SUBJECT: LA-6 Model.

DATE: October 31, 1933.

We release herewith the third installment of Machine Service Bulletin No. 161, Plates 22 to 28 inclusive, which illustrate and describe how to adjust the mechanism not covered in the first installment of this Bulletin.

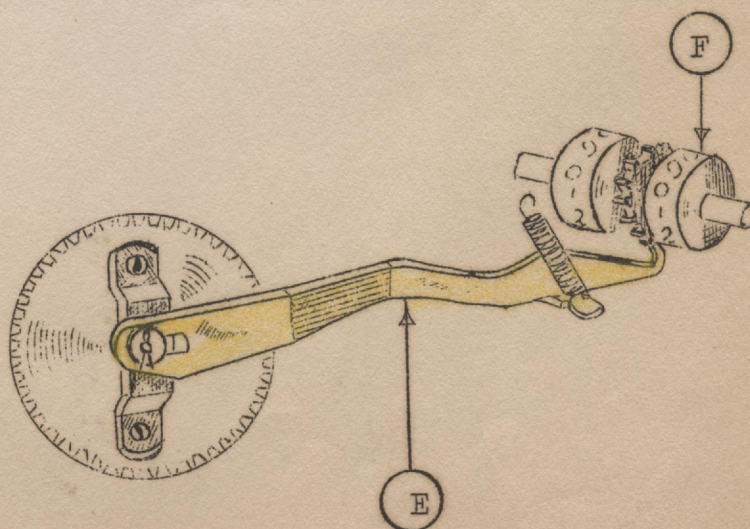
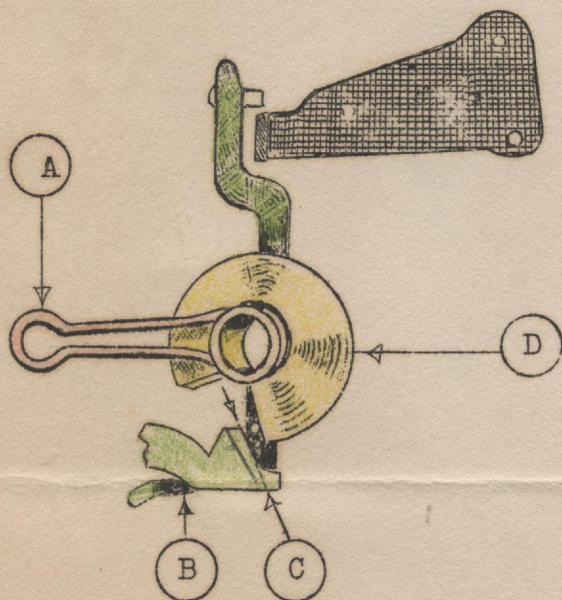
If during automatic division incorrect figures appear in the lower right hand dials, it is due to lock (B) striking the edge of cam (D) when the cycle stop arm is positioned against the bumper pad, thereby not allowing the lock to raise sufficiently high to permit the shifting of the carriage. This delay allows the counting finger (E), Figure 9, to engage the registering dials (F) twice and register accordingly.

This condition may be overcome by replacing the carriage lock cam with a cam having a larger notch or grinding $1/32$ " off the carriage lock (B) at (C), being careful to keep the original angle.

This condition may also be remedied in some cases by increasing the tension of the brake springs (A) on the carriage lock cams (D).

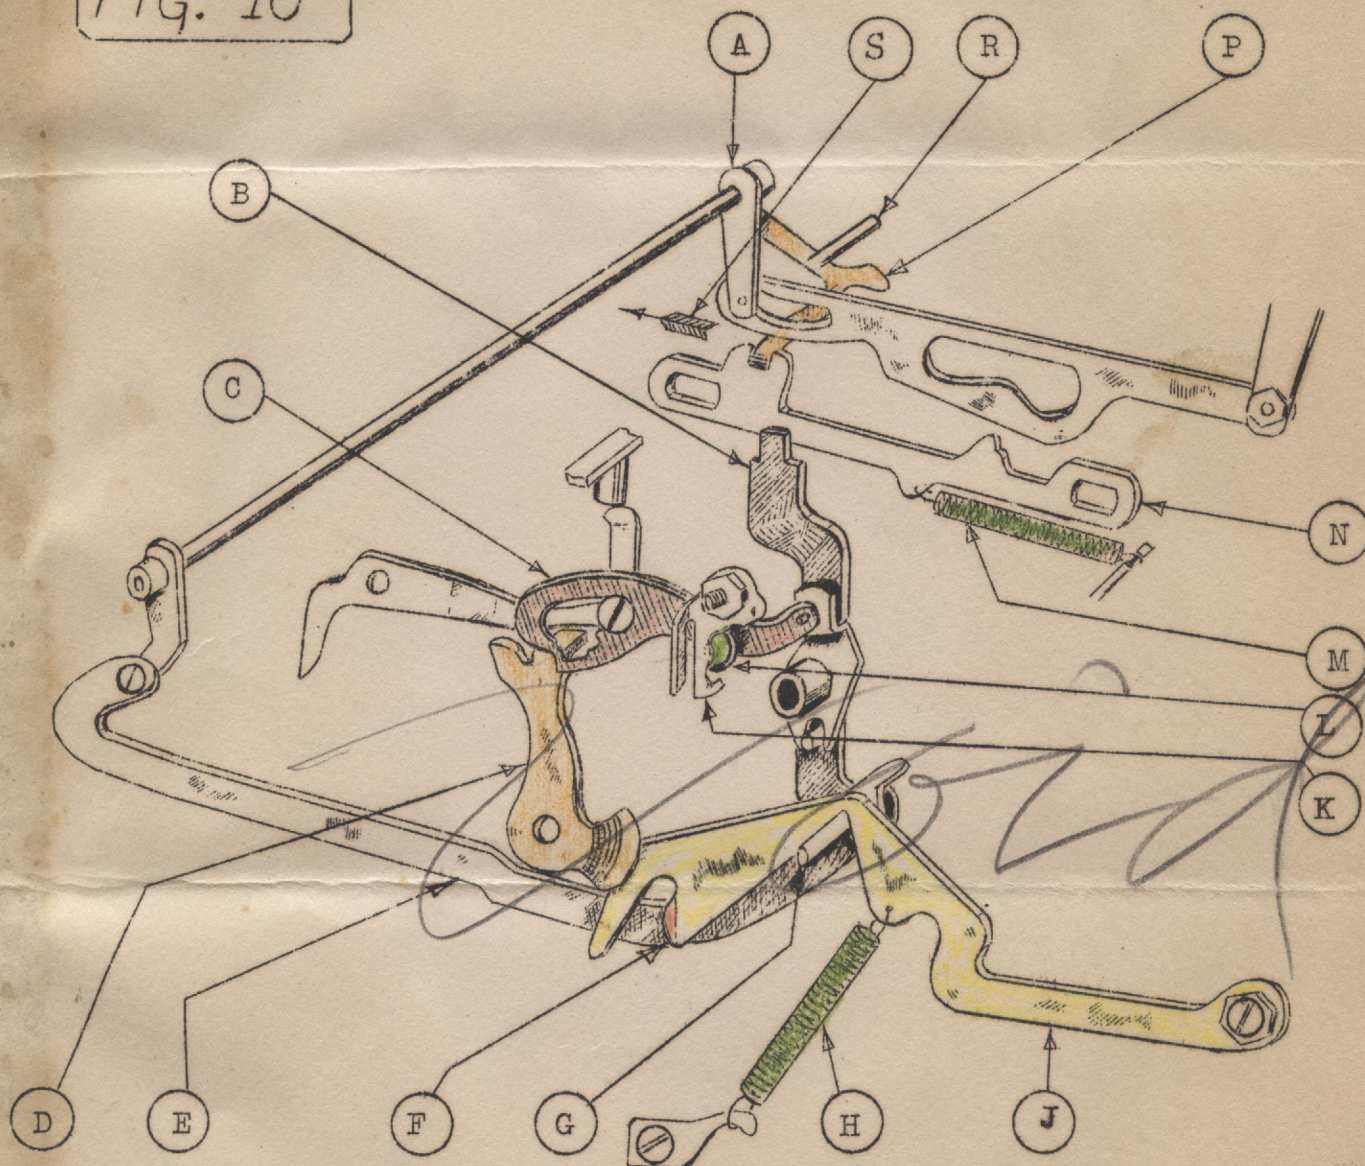
Additional stock, as shown in red, has been added to the division lever click (J) because when the multiplication lever was restored to neutral at the completion of a problem, the pin (R) on the main shaft gear would strike the lever (P) which, instead of pulling latch (N) in the direction of arrow (S), would apply pressure on arm (A) causing link (E) to move stud (G). The original click (J), due to the degree of angle at (F), could not prevent this.

NOTE: - Do not change the original tension of springs (H) and (M) as additional tension increases the load of restoring the division lever.
